Hi-Fi Products
Service Bulletin

Model: SEQ-411

No. 304

Subject: Power Board PCB Layout Change and Part Number Information: R414 and D411

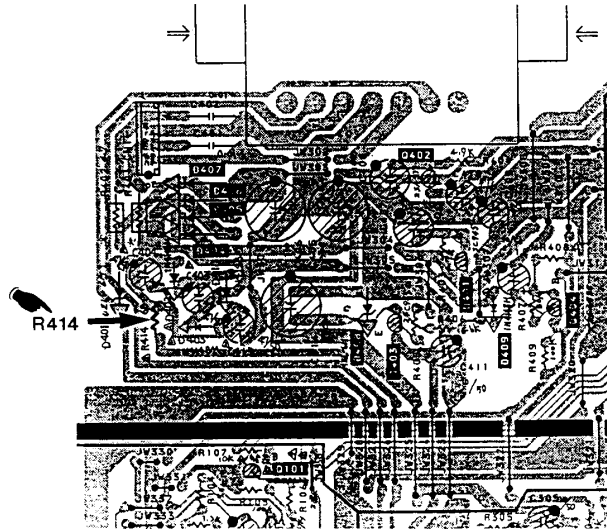
The power board PCB Layout has been changed and part numbers for R414 and D411 have been added.

The PCB layout of the power supply section has been changed. The new mounting diagram is shown below (boards with part number 1-638-580-12 printed on them).

Solution: Add the part numbers shown in the chart below to the Service Manual:

REFERENCE	DESCRIPTION	PART NUMBER
R414	68Ω 1/6W	1-249-403-11
D411	DIODE MTZJ33B	8-719-982-26
